Replacement of 2583601 with 2583605

Textar aims to streamline the designation of 2583601 to 2583605.

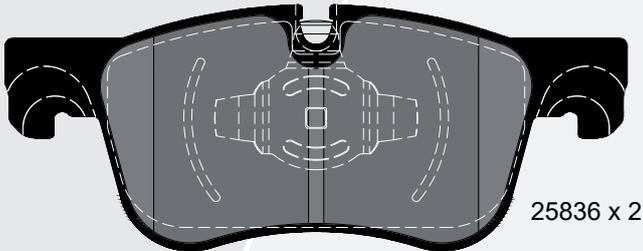
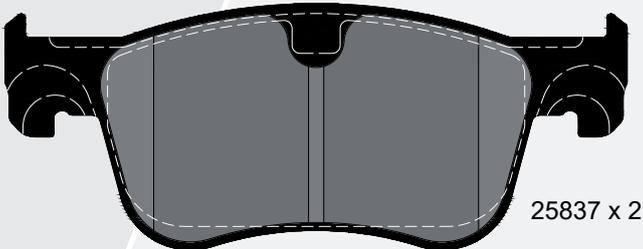
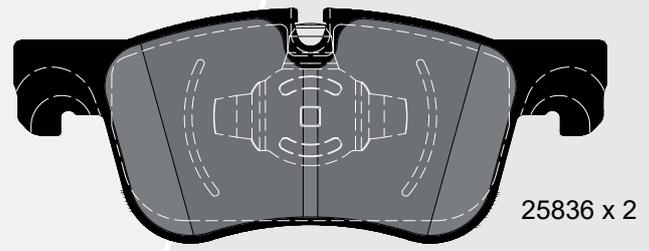
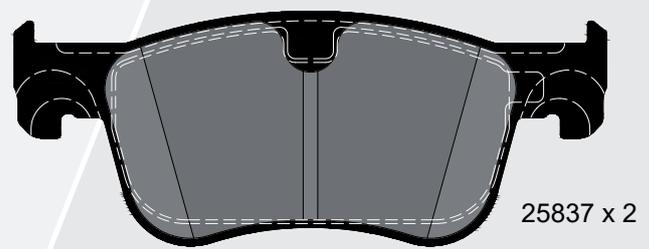
The difference between 2583605 and 2583601 is the 2583605 thickness is slightly thinner, the chamfers will be modified from parallel to segment, and a foil cover will be applied to 25837 WVAs.

Given the identical outer dimensions of the brake pads we can ensure seamless assembly and operation.
